Re: Offsite Environmental Assessment
 36-08 Review Avenue, Long Island City, NY 11101
 BCP Site No. C241218

Tenen Environmental, LLC (Tenen) has prepared this offsite environmental assessment for the above-referenced Site. This letter is intended as a response to the comments provided by NYSDEC to Tenen in an email dated November 22, 2022 and during a phone call on December 20, 2022.

Figure 10a

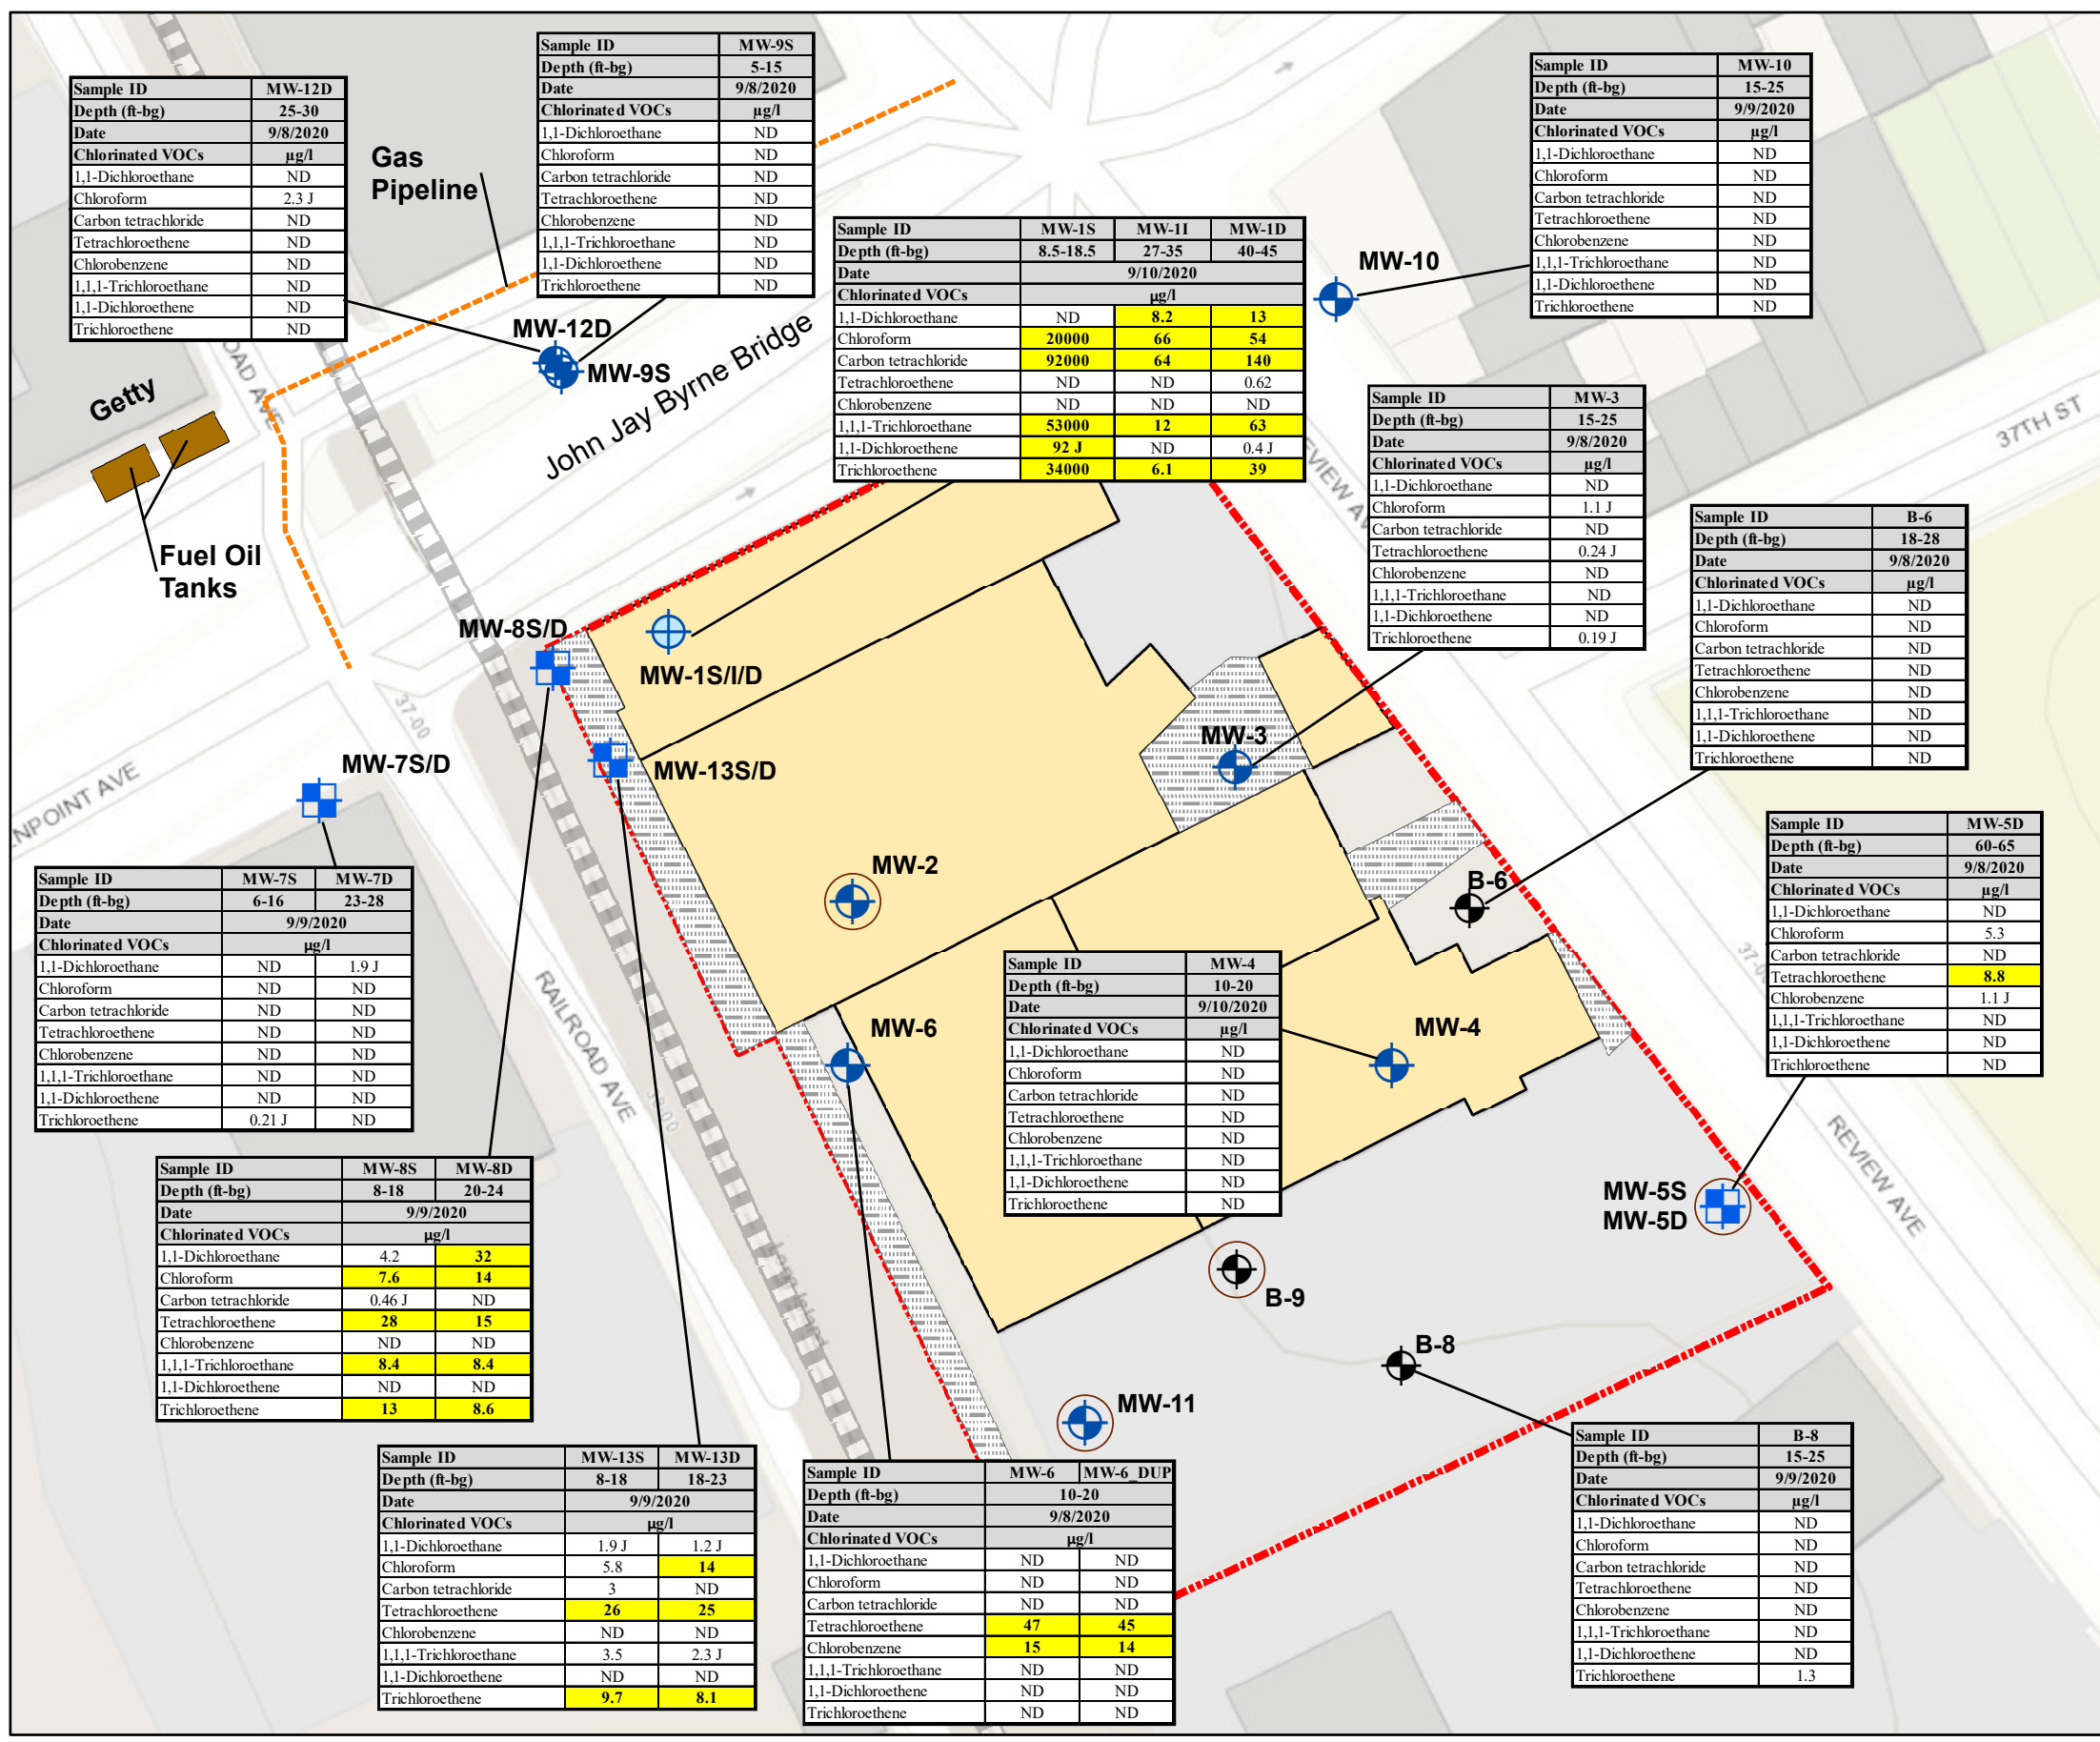
In NYSDEC's email dated November 22, 2022, the following comment was provided: "Regarding the carbon tetrachloride; the data indicate off site migration via groundwater and probably soil vapor. Excavation and chemox may not be sufficient to prevent off-site migration and a perimeter [soil vapor extraction system] (SVE), maybe [air sparging] (AS)/SVE, is recommended."

As shown on Figure 10a included in the July 2021 Remedial Investigation Report (RIR) (and included in Attachment 2), within the cVOC source area in the northwestern portion of the Site, the highest concentrations of cVOCs were detected in monitoring well MW-1S (shallow well) and MW-1D (deep well). Two monitoring well clusters, MW-8S/D and MW-13S/D are located on-site and downgradient of MW-1S/D. One monitoring well cluster, MW-7S/D, is located downgradient of the Site, across Railroad Avenue in the sidewalk of the Greenpoint Avenue access road. The concentrations of all cVOCs detected above the Class GA Standards in these wells are presented below with exceedances highlighted in yellow.

No cVOCs were detected above the Class GA Standards in the off-site wells. Carbon tetrachloride and 1,1-dichloroethene were not detected in exceedance of Class GA Standards in any offsite groundwater monitoring wells. The concentrations of 1,1,1-trichloroethane (1,1,1-TCA), trichloroethene (TCE) and chloroform detected in the shallow downgradient monitoring wells are three to four orders of magnitude lower than in the cVOC hotspot (and generally one to two orders lower in the deep interval).

Based upon the concentrations of cVOCs detected in these three sets of cluster wells and the distance between these wells, it is unlikely that groundwater beneath Railroad Avenue or properties west of Railroad Avenue contains significant concentrations of cVOCs requiring remediation in addition to what is proposed in the draft RAWP.
